RHODE ISLAND CONTRACT NO.2017-CB-070

**Horton Farm Bridge No. 472**

**NOTICE TO PROSPECTIVE BIDDERS**

ADDENDUM NO. 5    Prospective bidders and all concerned are hereby notified of the following changes in the Plans, Specifications, Proposal and Distribution of Quantities for this contract. These changes shall be incorporated in the Plans, Specifications, Proposal and Distribution of Quantities, and shall become an integral part of the Contract Documents.

PIER PLAN AND ELEVATION

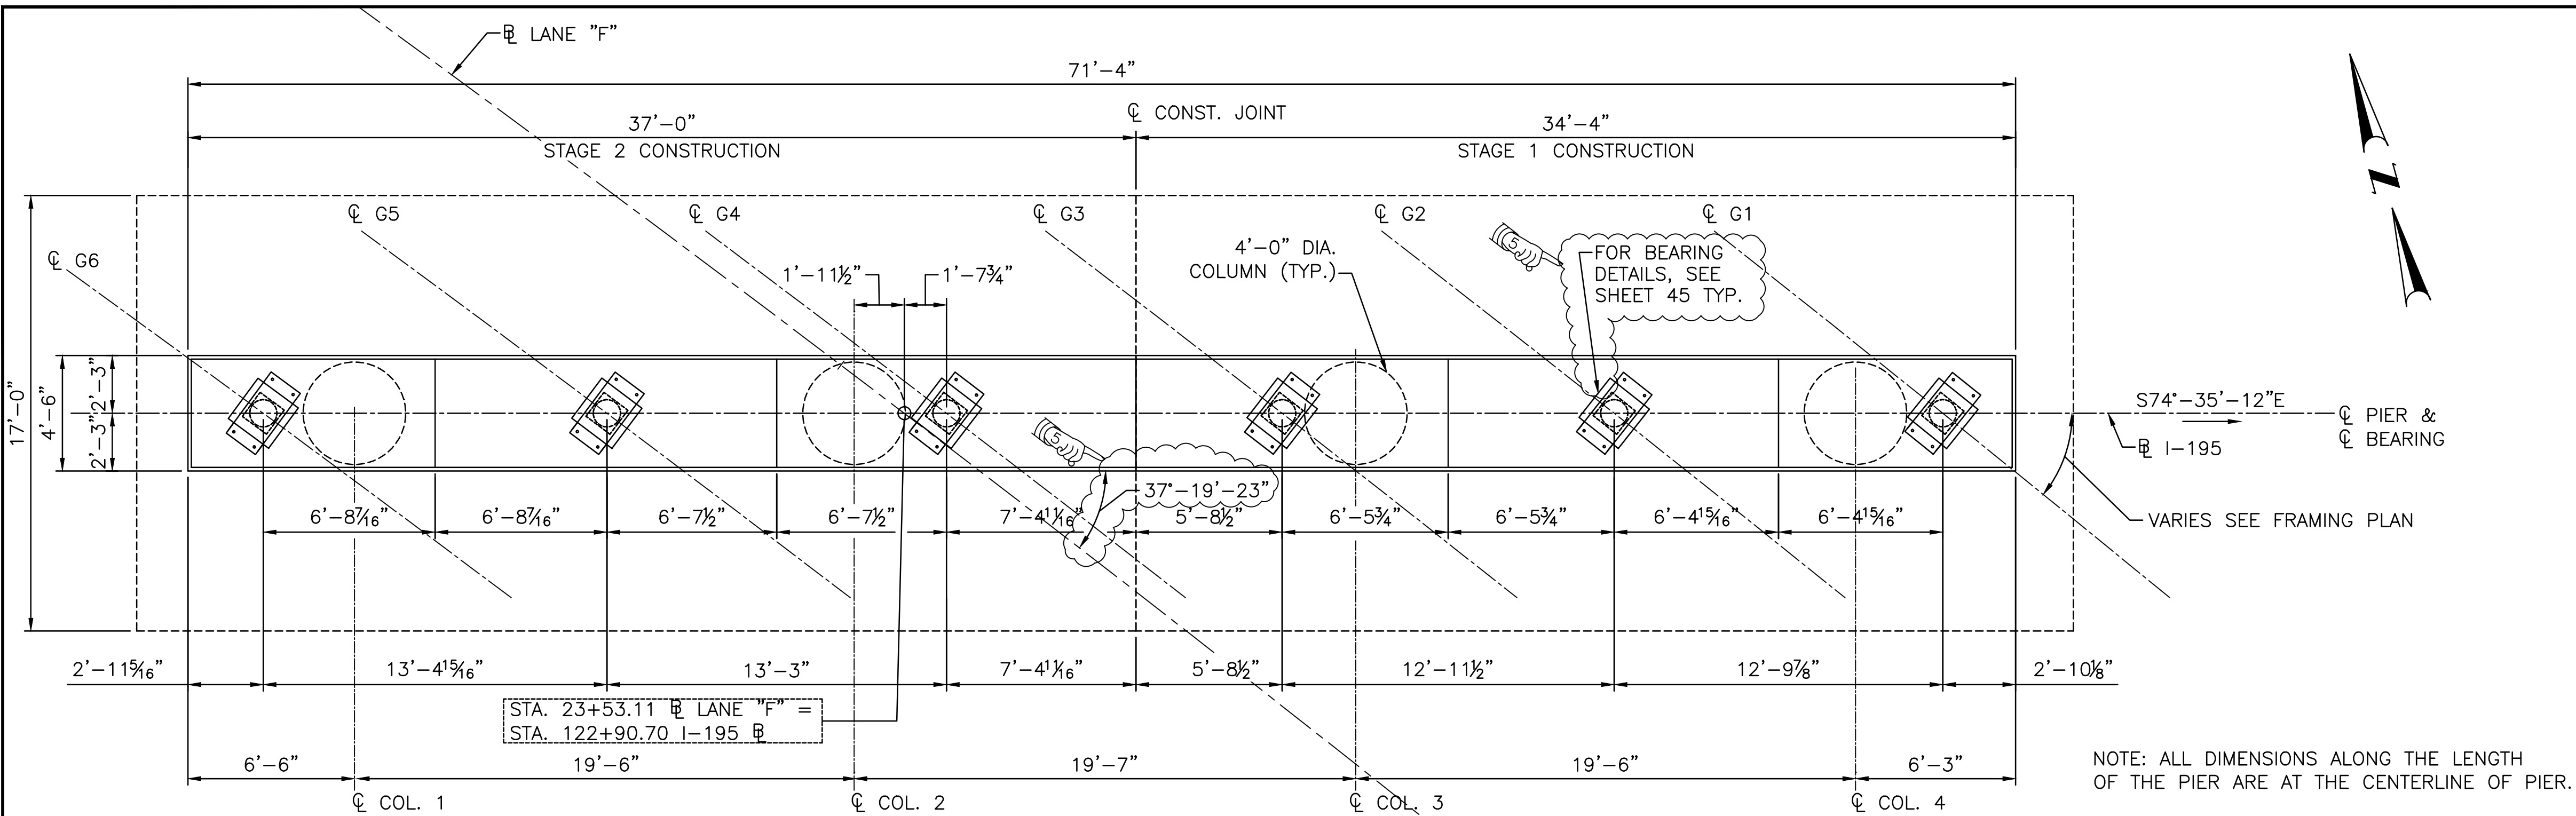
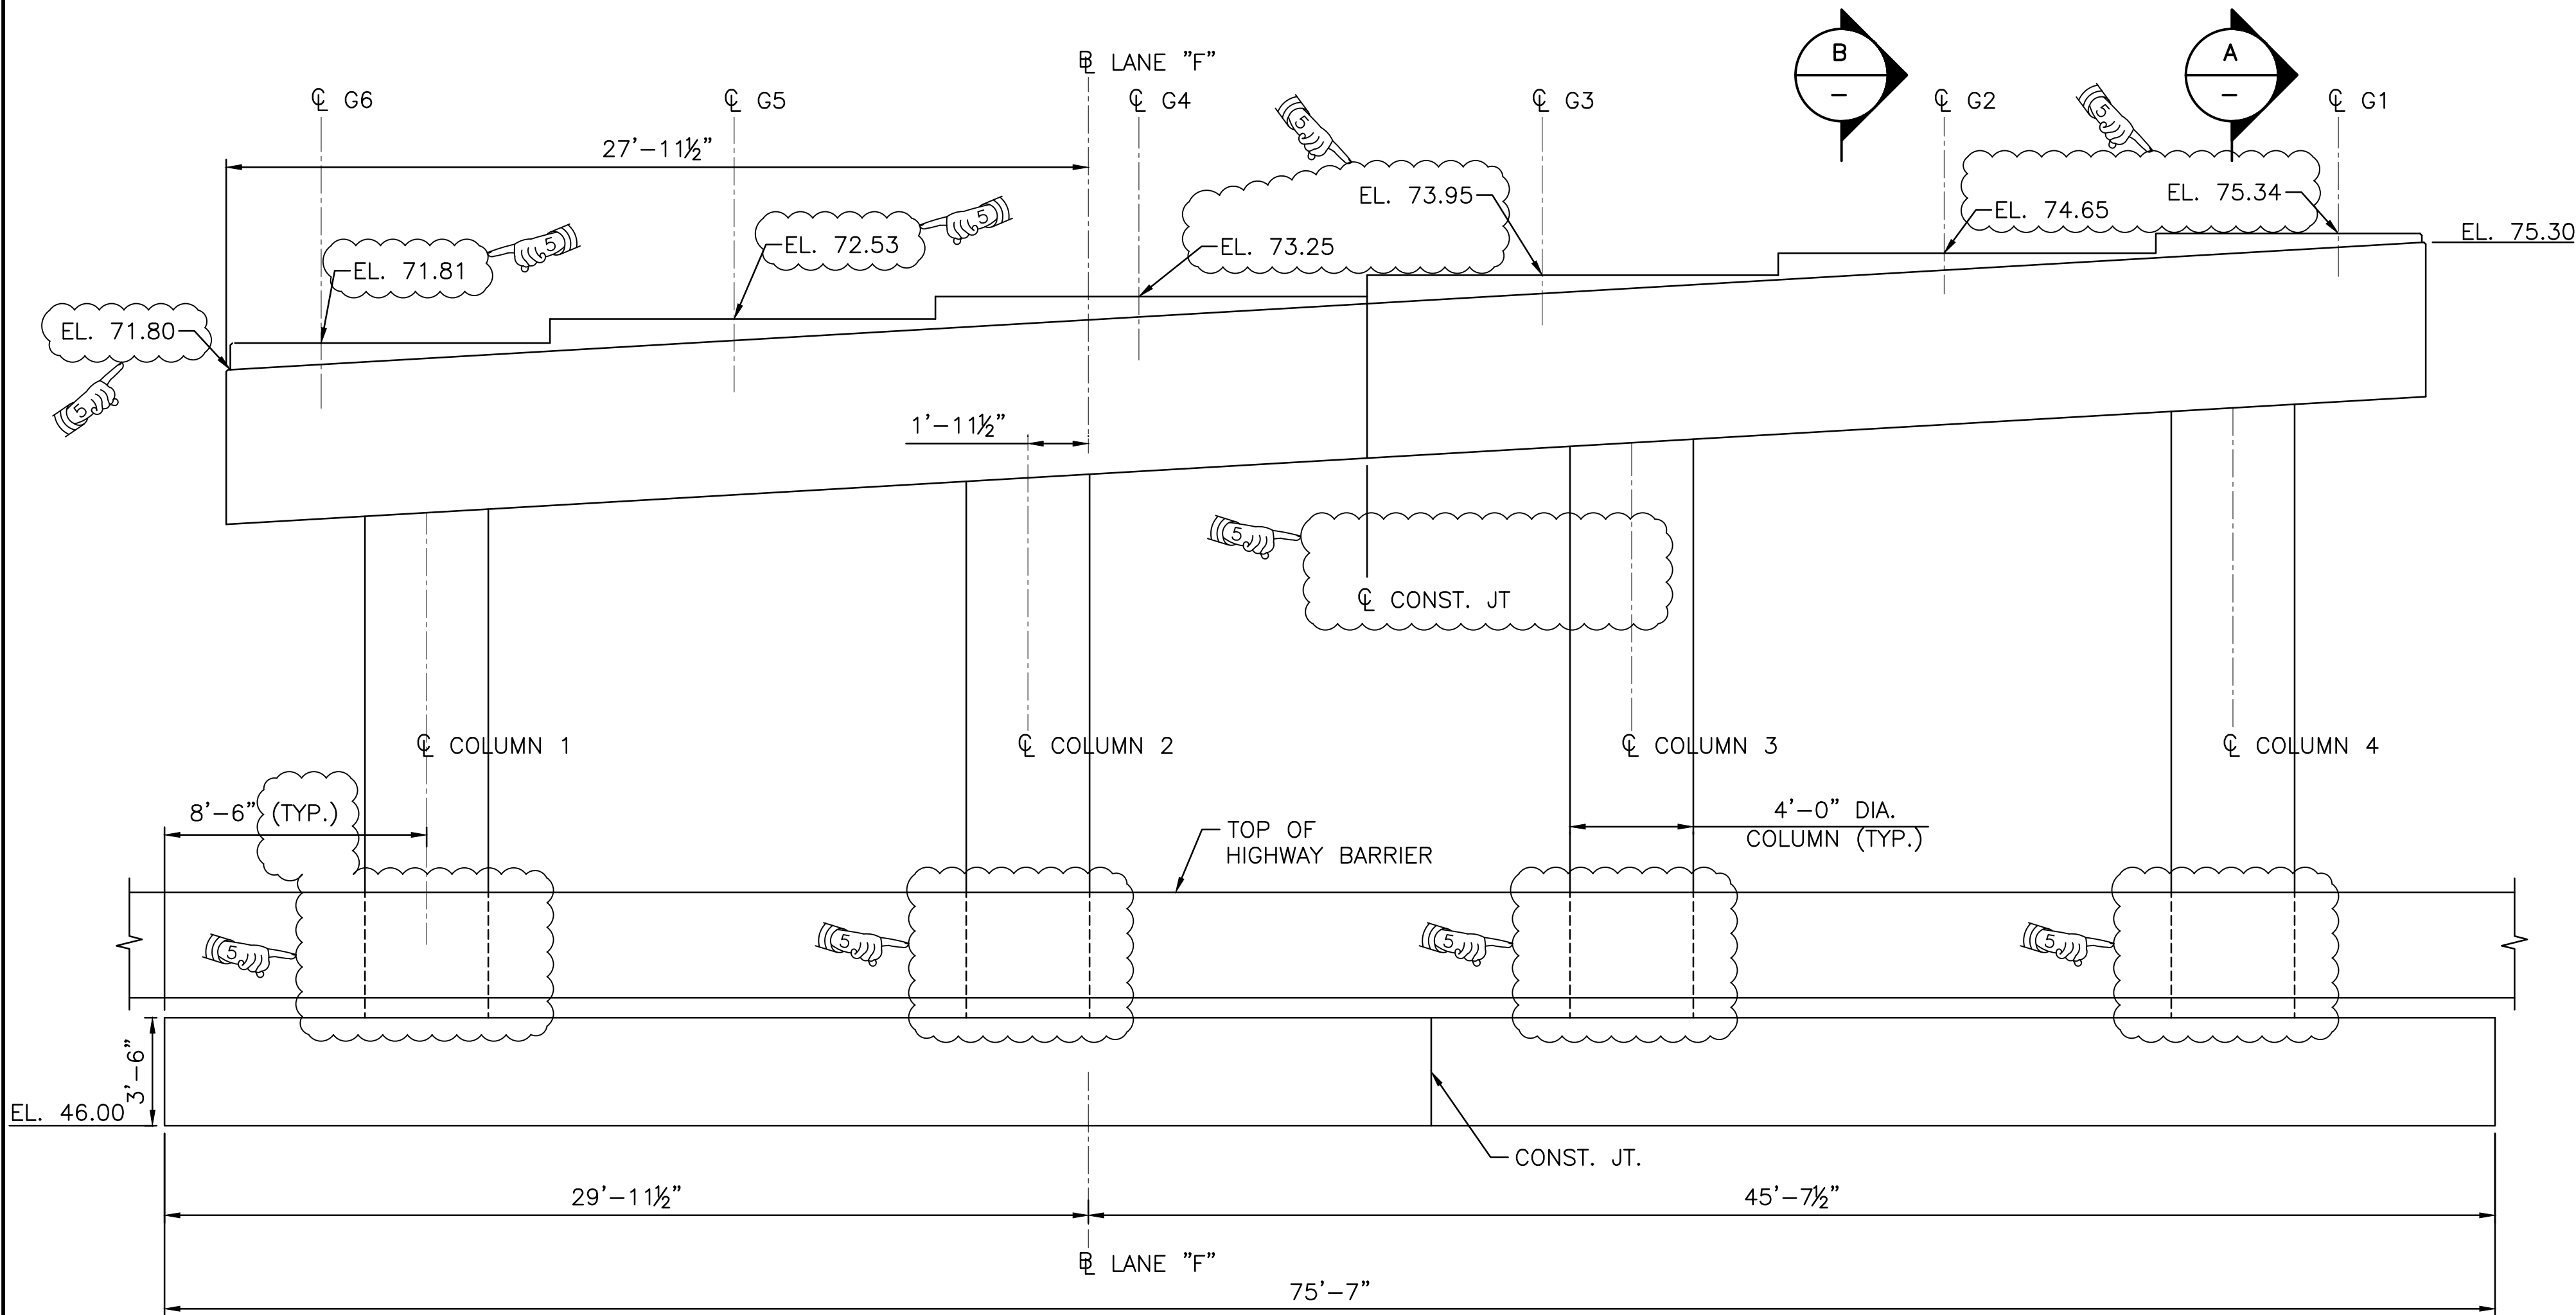
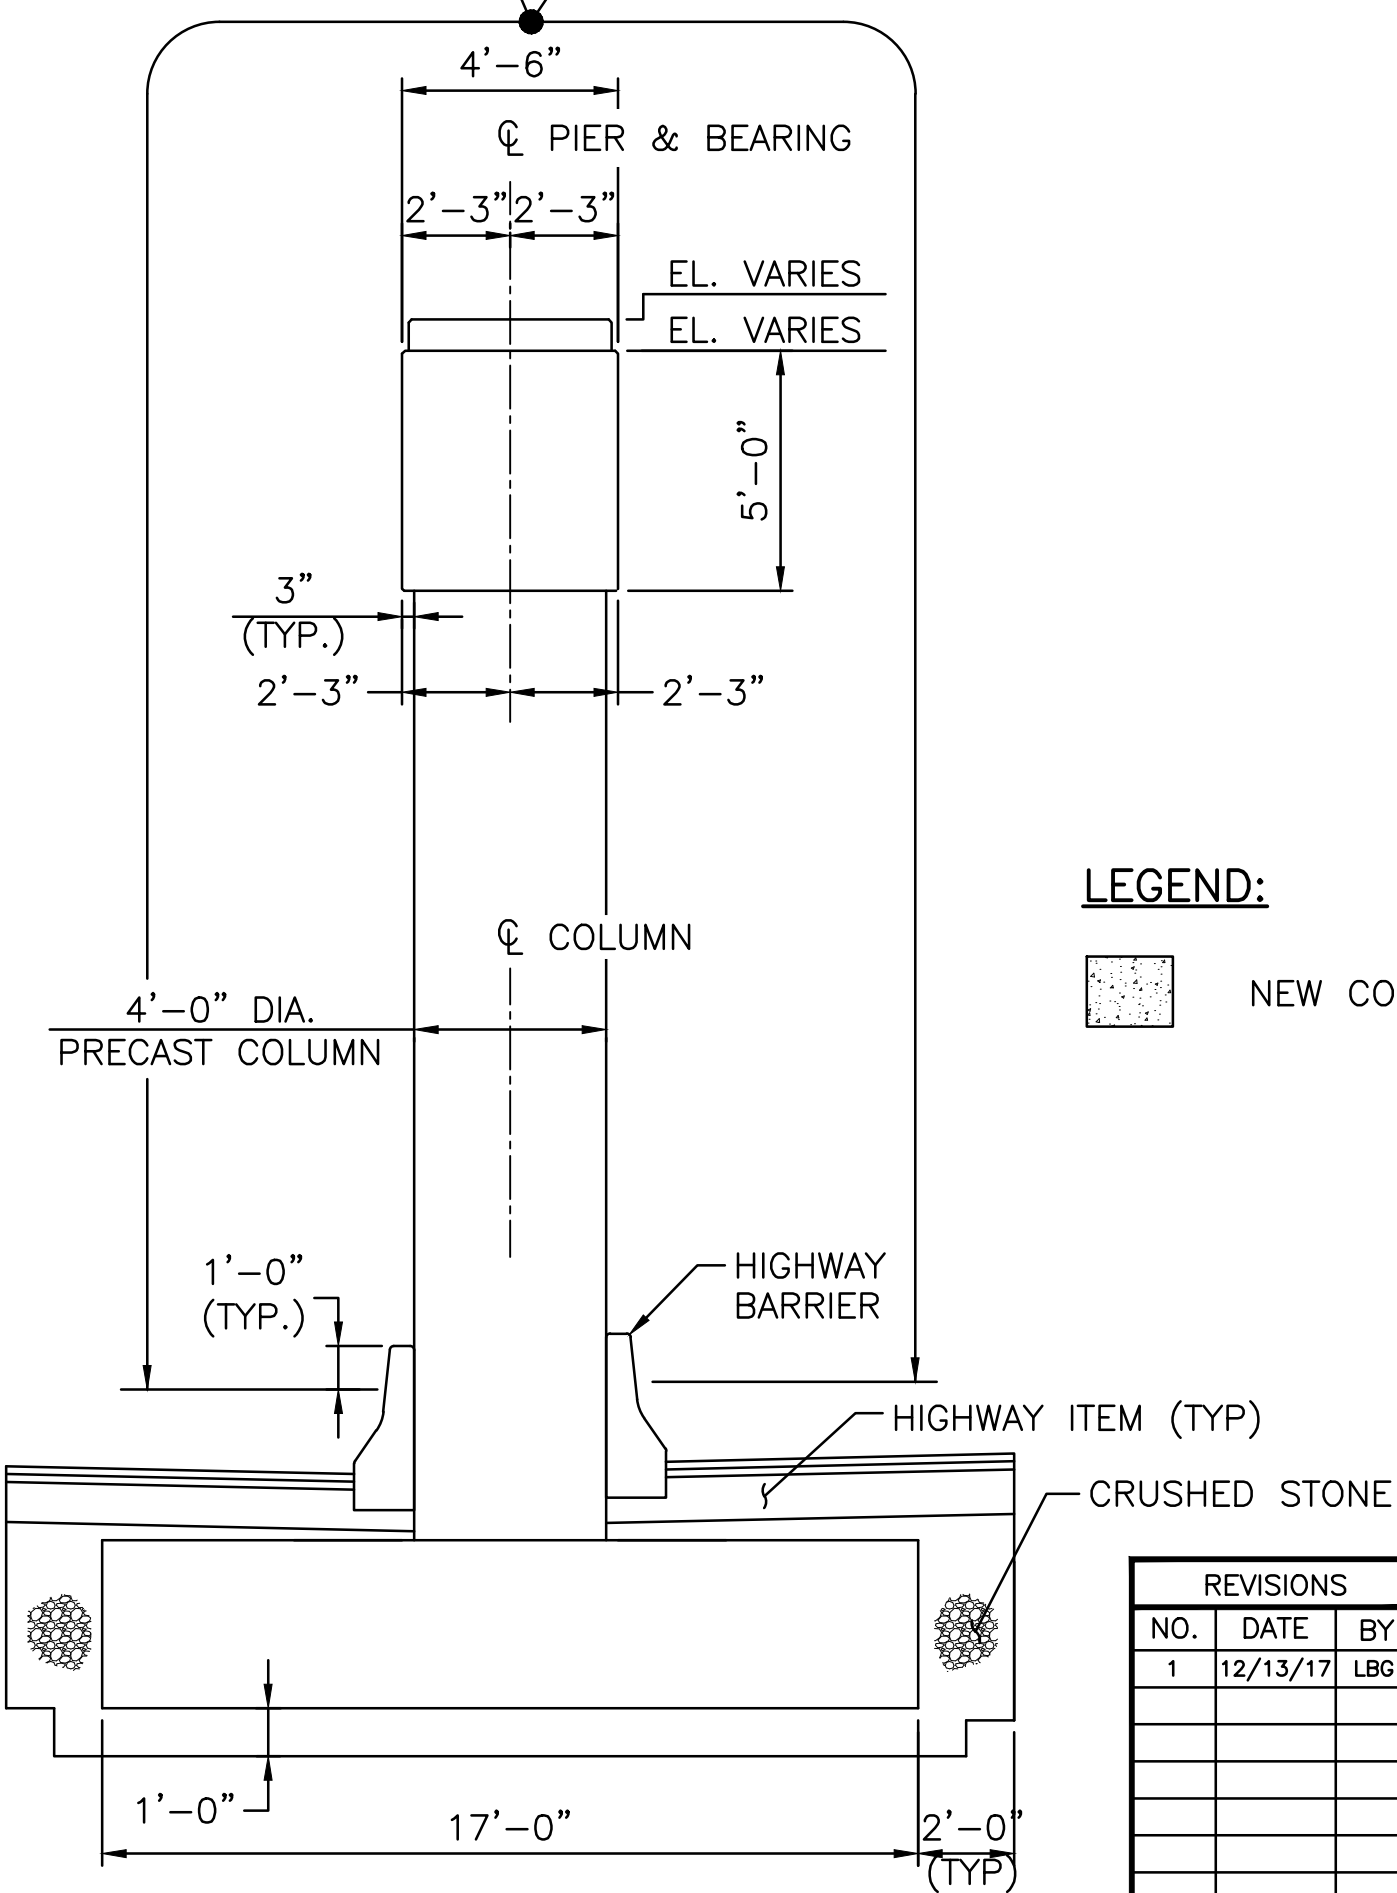
8. VOLUME 2 SHEET 29 - PIER PLAN AND ELEVATION  
Remove and replace Sheet 29 in its entirety with Sheet 29(R-1) attached to this Addendum No. 5.  
This sheet has been revised.
